Subject: Victoria Restaurant, Special Permit Application  
320 Lombard Street, Syracuse, NY

Subject: 320 Lombard Street & Wescott St, Syracuse, 13210  
Special Permit, SP-23-04  
Zoning Appeal, E-23-01

Review comments of Zoning Administration and comments.

SITE PLAN

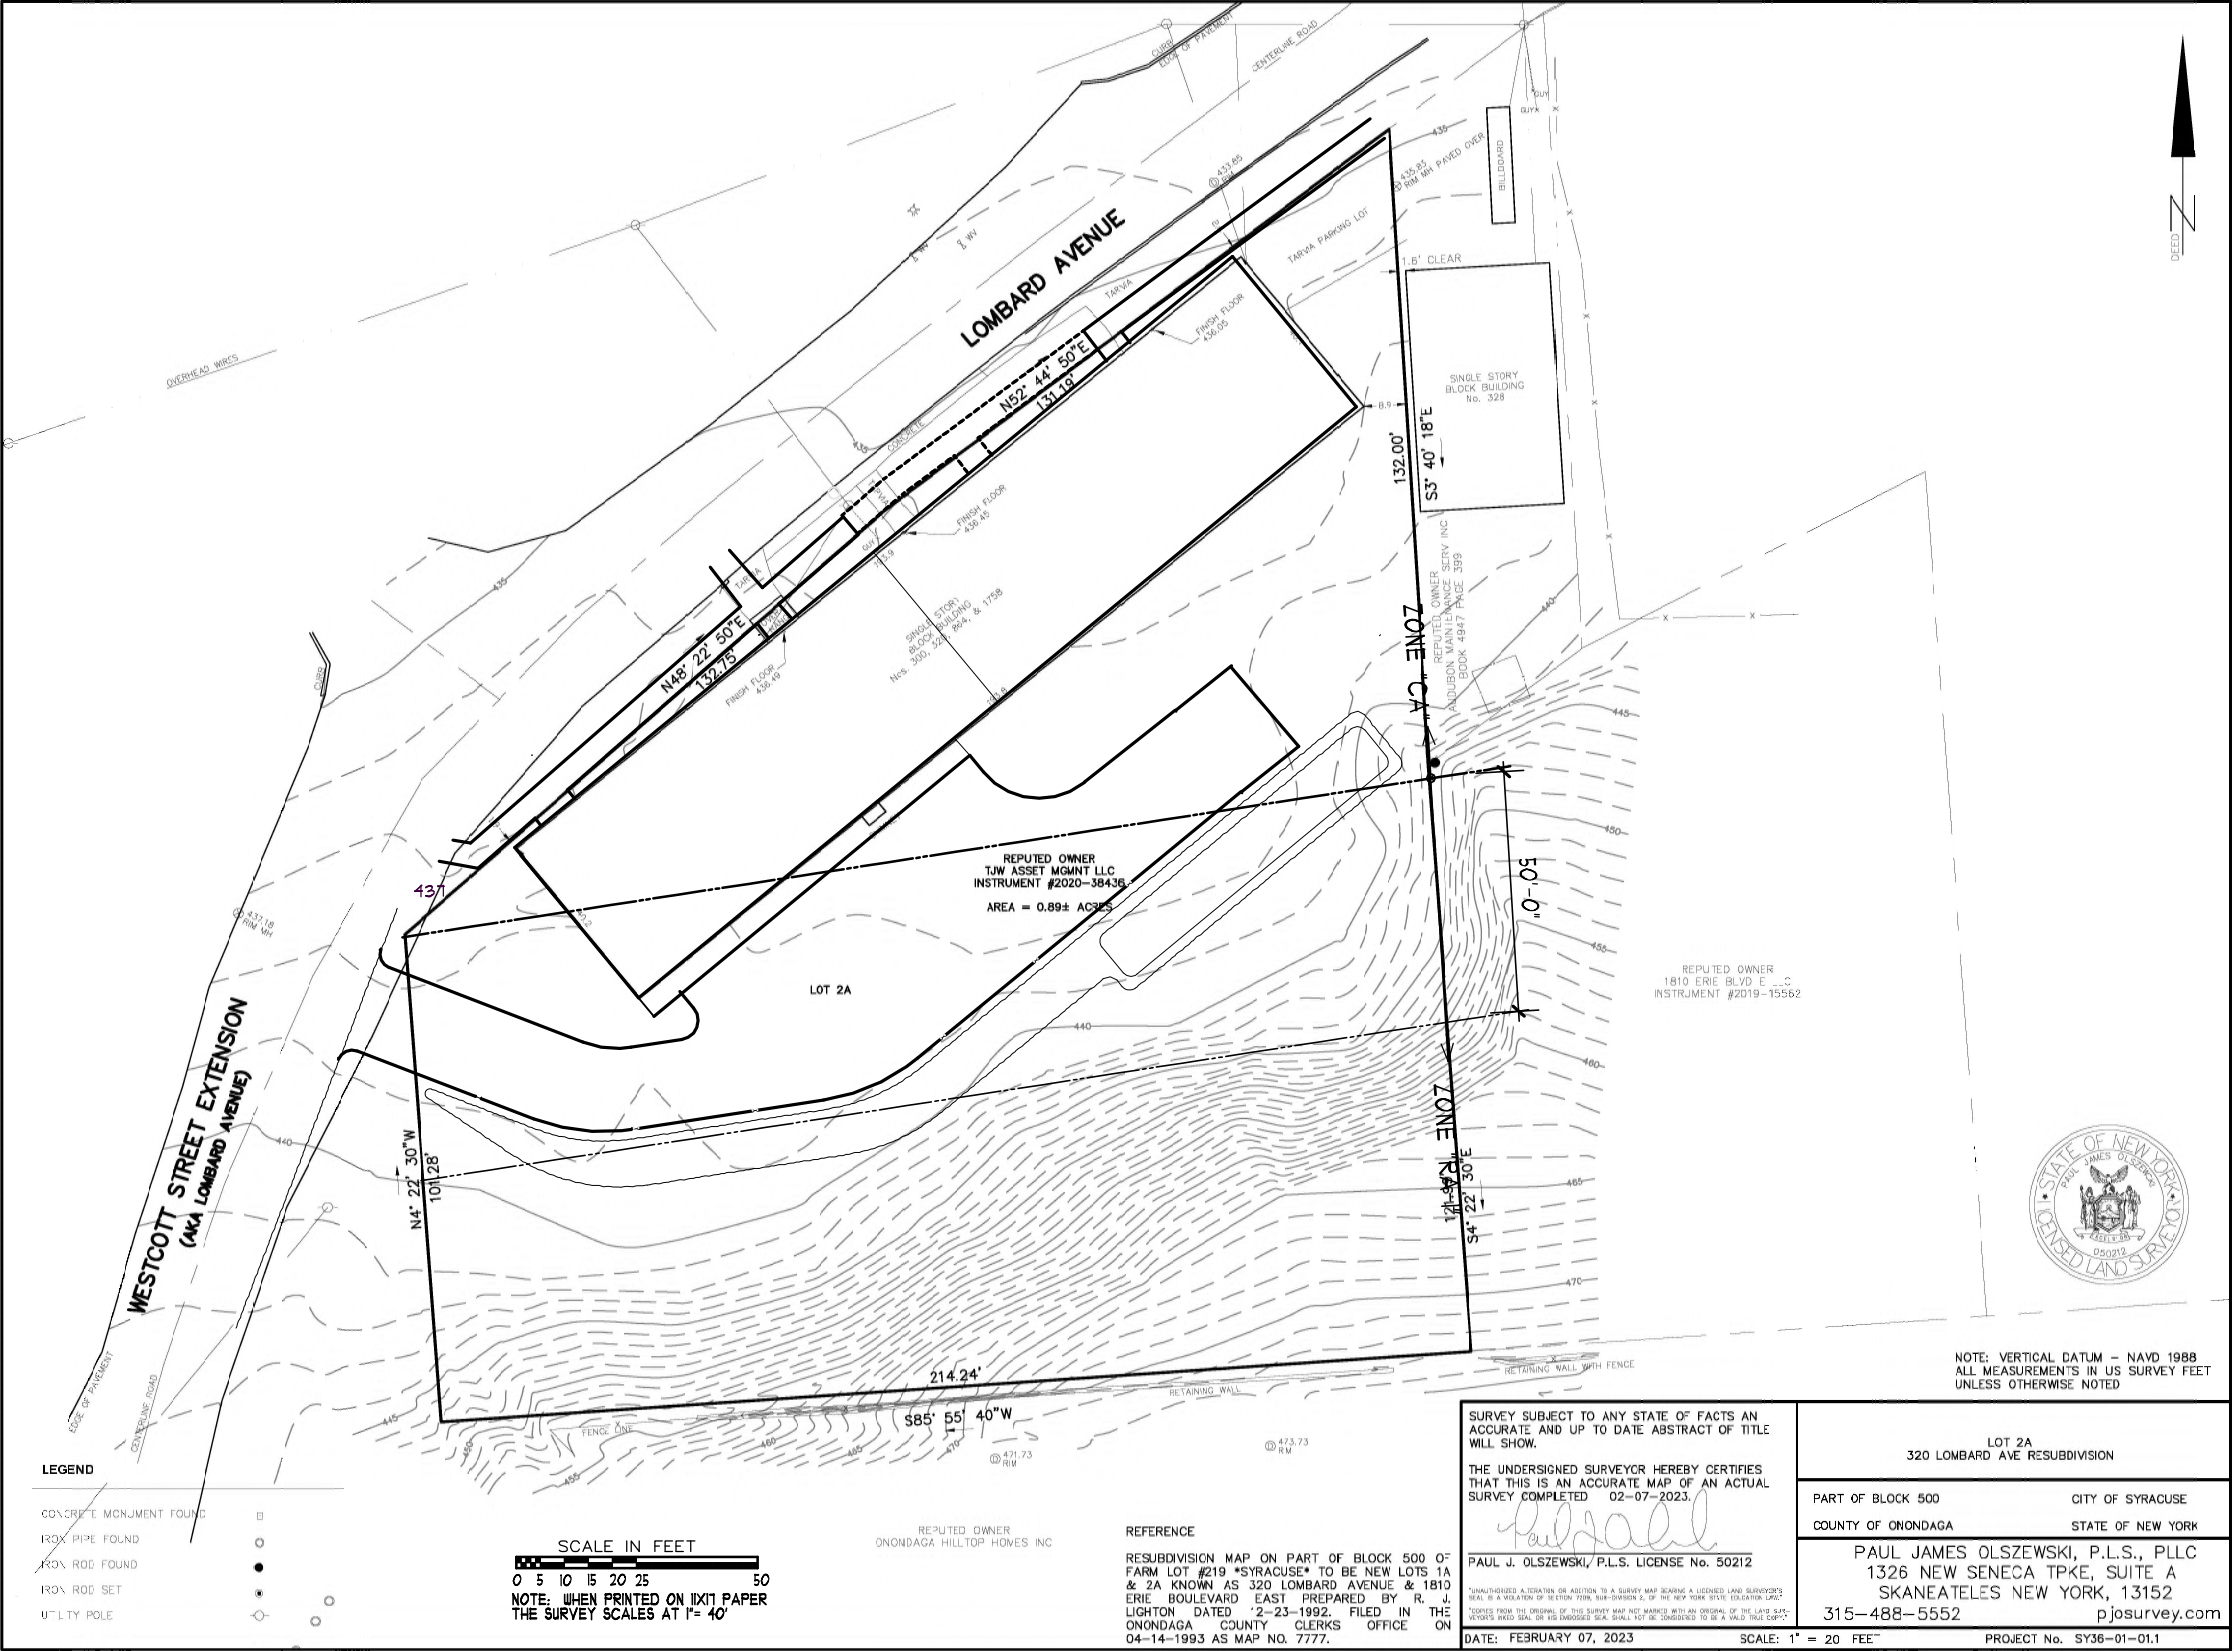
As previously noted by Zoning review, the following changes are made to drawing L-2, dated Revision 2 1-31-2023.

- In zone RA-1 non-residential parking is prohibited. As shown on the drawing, the parking lot has been redesigned to be contained within the 50-foot Exemption area of zone RA-1. The applicant requests an Area Variance waiver for this parking.

- as noted by Zoning review, the dumpster area has been moved from Zone RA-1 to Zone CA.
- The driveway has been reoriented to be perpendicular to Lombard, and the width increased to two-way traffic.

REVISION 2:  
MOVED DUMPSTER TO ZONE "CA" FROM ZONE "RA-1"  
KEPT ALL PARKING WITHIN 50-FOOT EXCEPTION ZONE FROM CA/RA-1 BOUNDARY

TOPOGRAPHIC  
SURVEY  
FEB. 2023

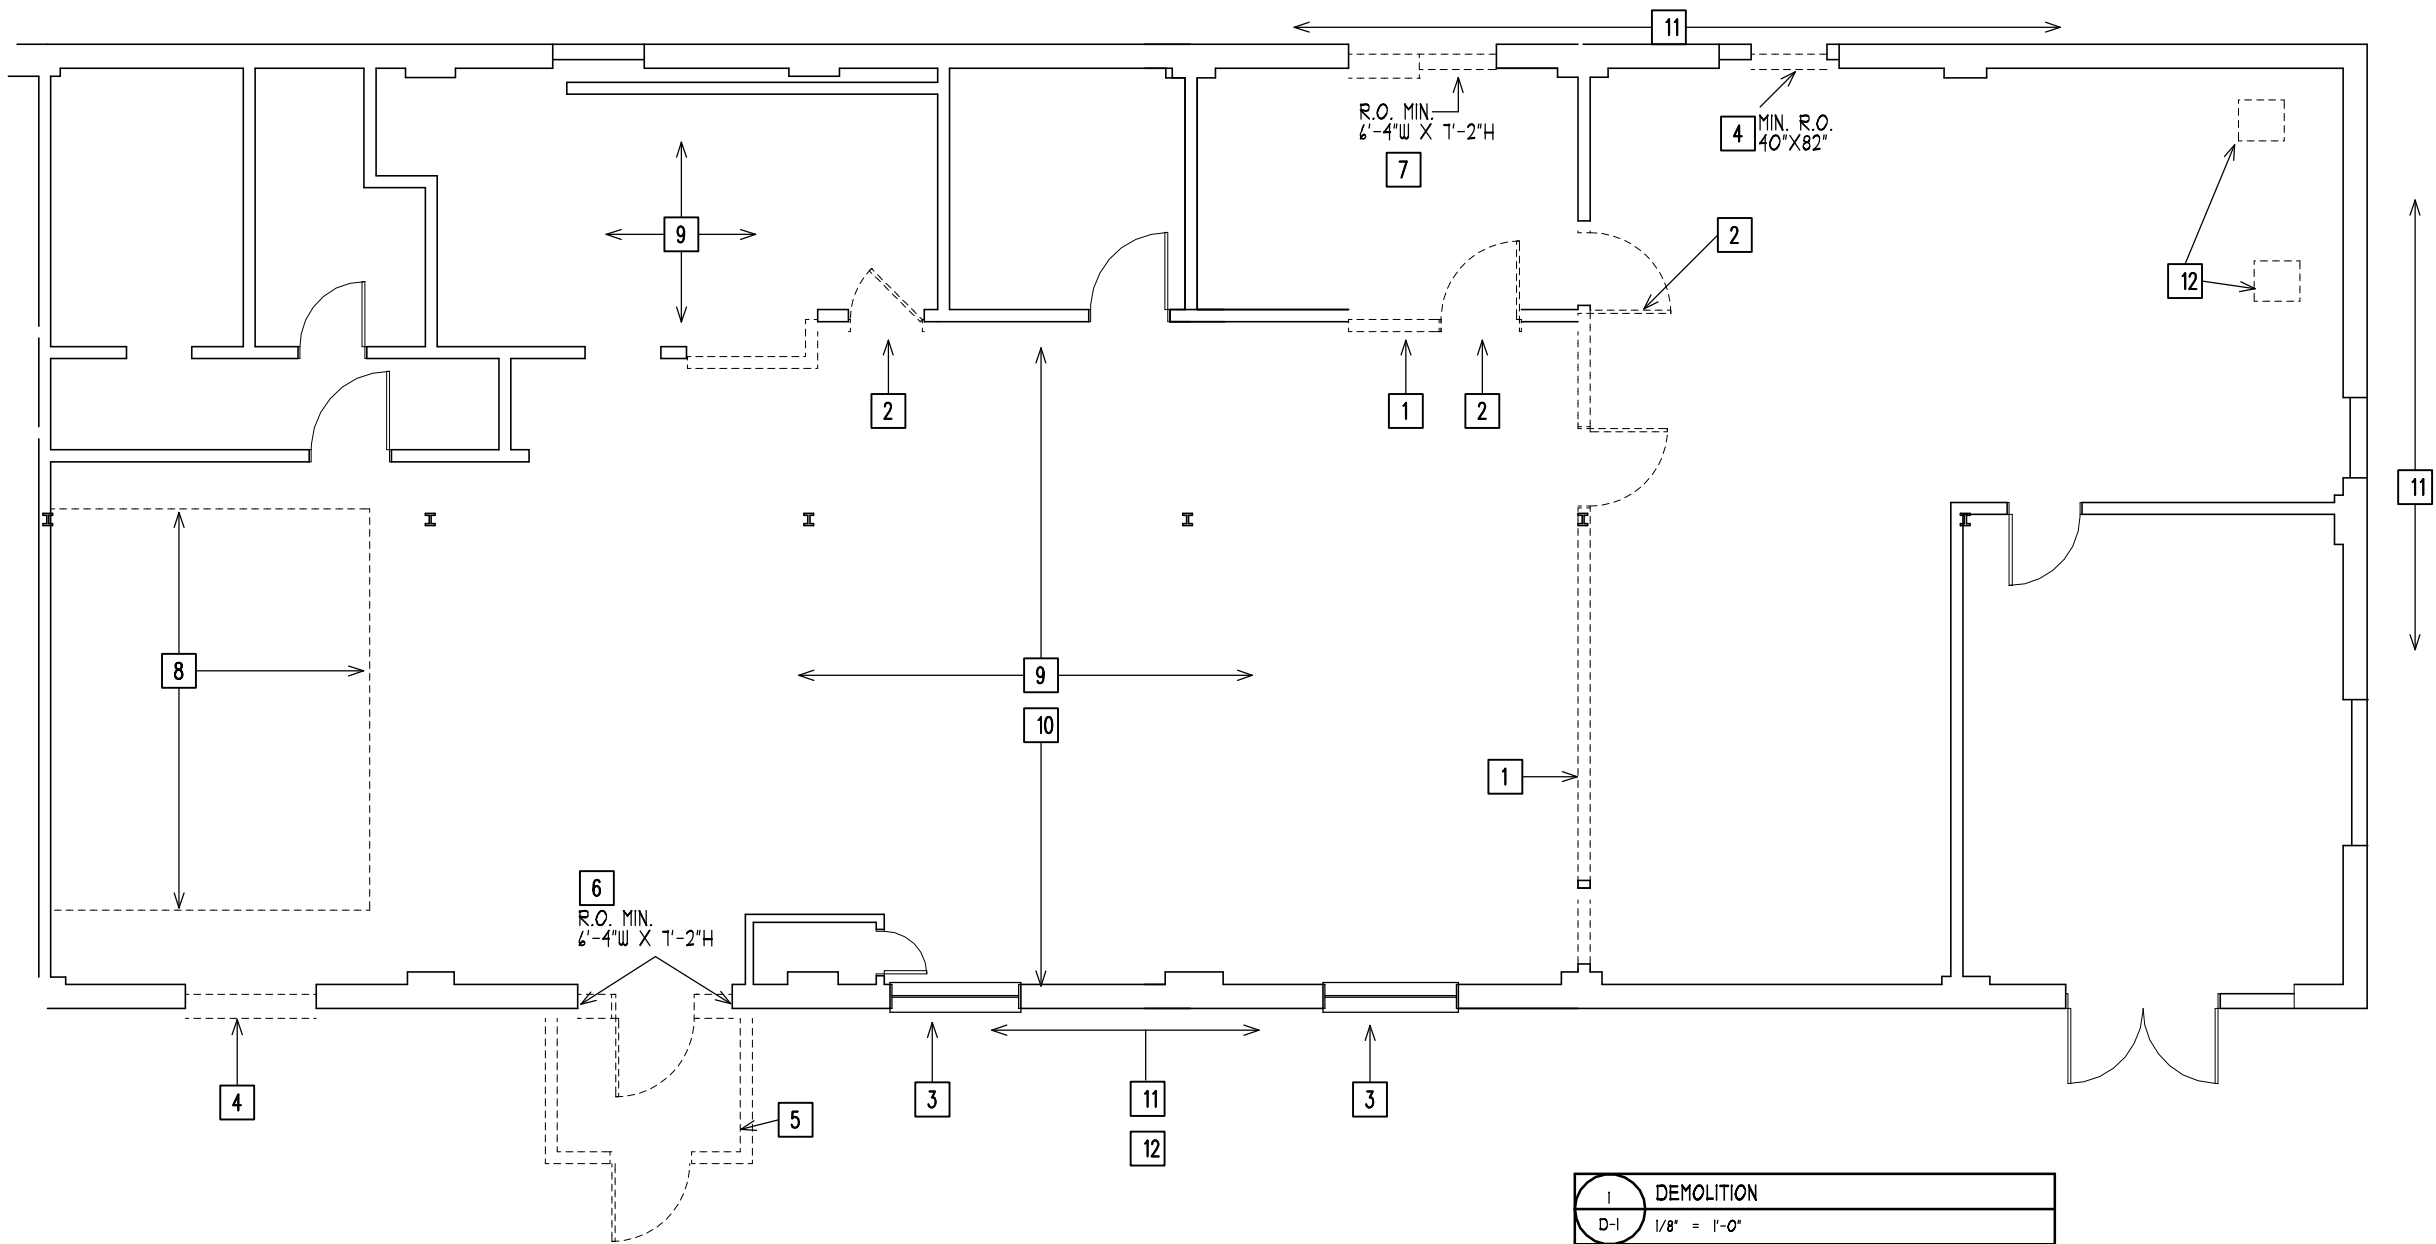
Sidewalks: See attached drawing L-3, showing topographic elevations, and photographs.

- Drawing L-3 shows a very steep slope at the southwest corner that would require stairs. In all likelihood, such walkways along the pavement edge would require Encroachment Approval.
